SUBJECT: Additional Attachments for Agenda Item 4.a for Meeting of December 4, 2017

The staff report for agenda item 4.a, City Council review of the Planning Administrator's decision for Phased Subdivision / Class 2 Adjustment Case No. SUB-UGA17-09 (17-577) included the Planning Administrator's October 30, 2017 decision order on the case as Attachment 3. The decision document incorporated seven attachments which were omitted from the staff report for this agenda item. The decision order attachments are attached to this memo, and will be sent out as an addition.

**DOGWOOD
HEIGHTS**

**PRELIMINARY PLAN
COVER SHEET**

PRELIMINARY PLAN
COVER SHEET

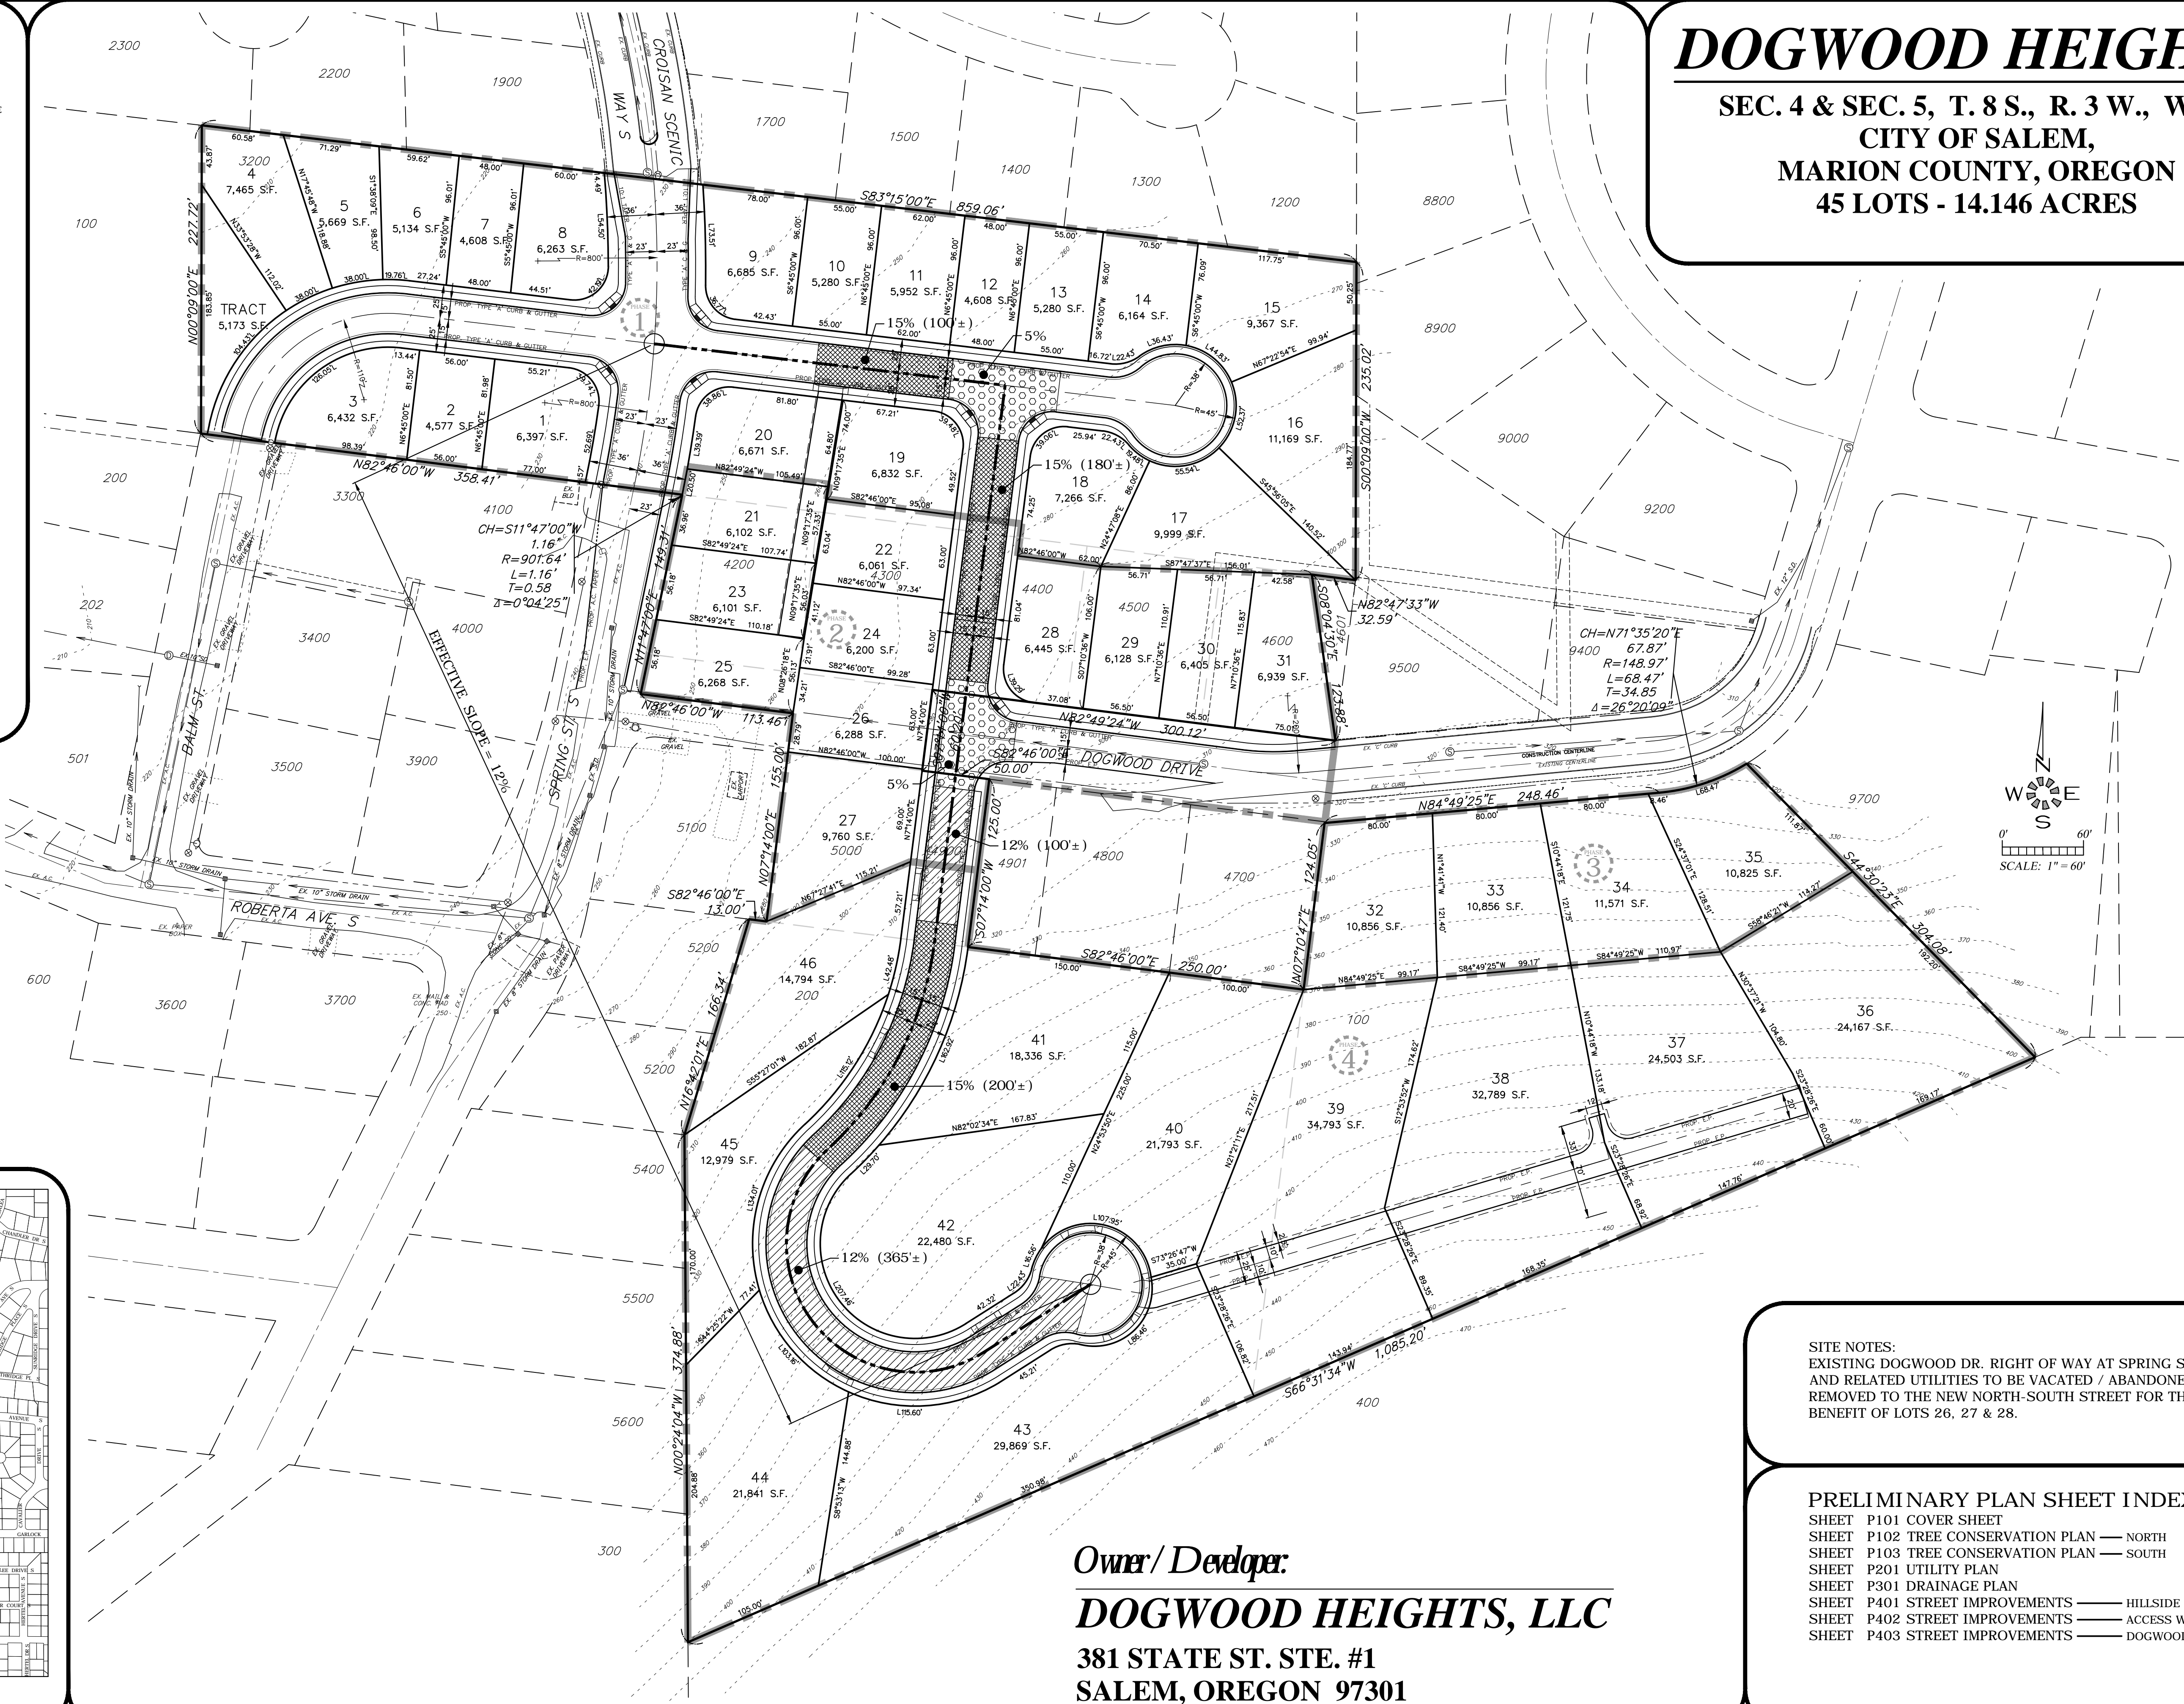
The applicant is requesting a Class-2 Adjustment to allow the new streets with the proposed Dogwood Heights project to exceed a 12-percent street grade in the areas denoted on Sheet P101.

(A) The applicant is requesting an adjustment to street grades. As shown on the Preliminary Plan Cover Sheet, P101 and detailed on the street section provided (Sheet P401), the above-mentioned streets will have sections of the roadway with a 15% street grade. Due to the topography of the site and the proposed street alignment with existing streets, this street will exceed 12% street grade. The areas proposed for slopes in excess of 12% are denoted on the plans and will not exceed a single run length of 200 feet.
